UNITED STATES PATENT AND TRADEMARK OFFICE

Office Action Summary	Application No.	Applicant(s)	
	10/718,929	GUTHRIE ET AL.	
	Examiner	Art Unit	
	Carlos Lugo	3676

DETAILED ACTION

Attachment #1

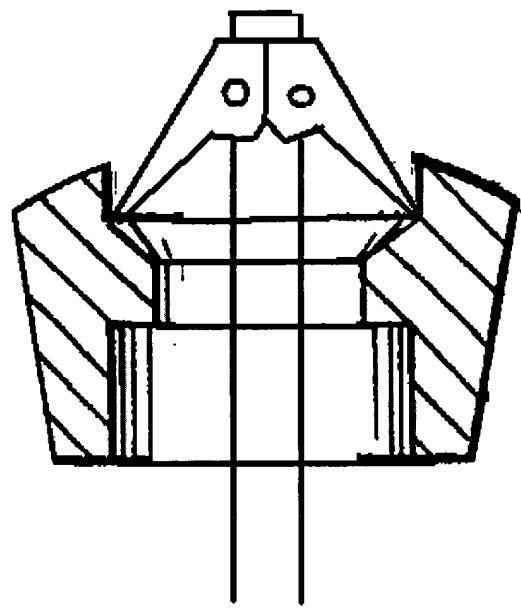
The applicant further argues that Hamlin fails to teach that the end of the toggle bar is adapted for locking engagement with the hole plug in the closed position.

As seen in attachment #1, Hamlin teaches a plug (36) that includes a recess that is capable of receiving and holding a toggle bar in a closed position. Therefore, the argument is not persuasive.
